Document under Review: **P802.16e/D7**Ballot Number: **0001037**

Comment Date

Dedicated DL Control IE {

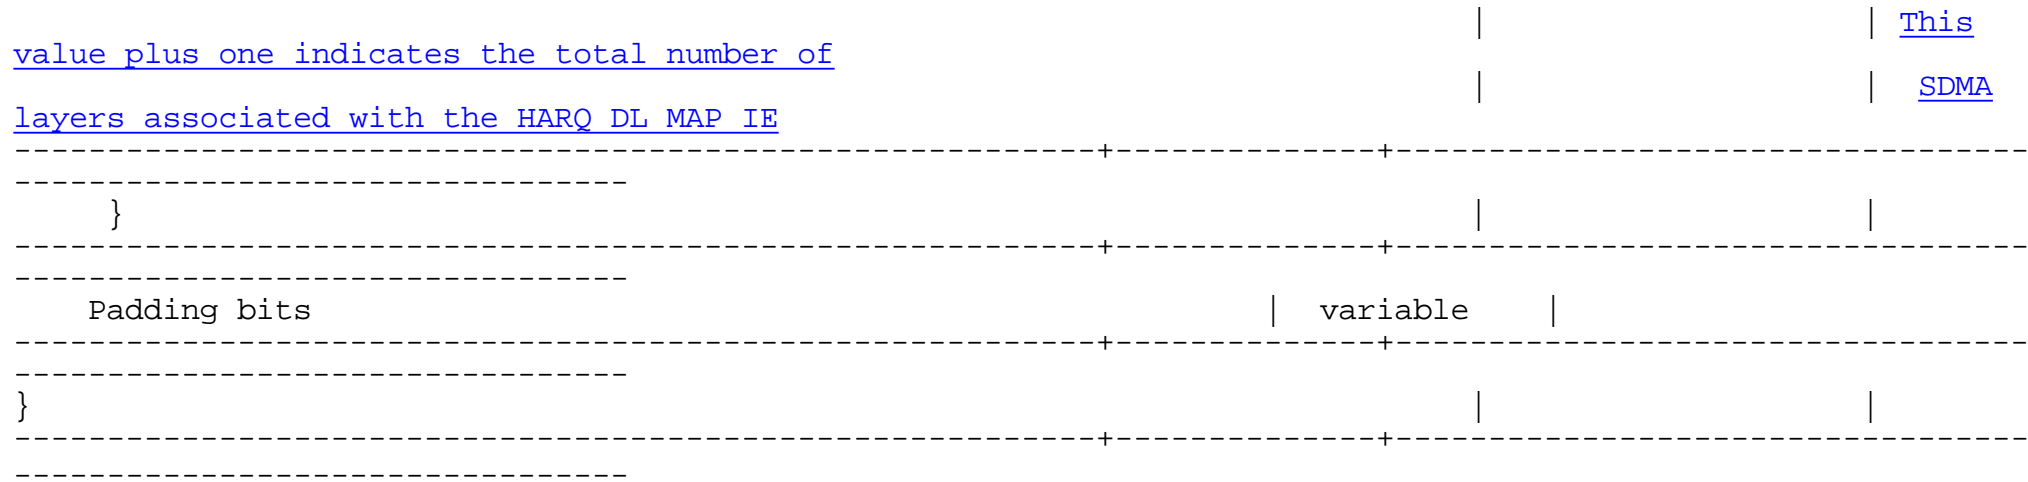
Num SDMA layers
~~minus 1~~
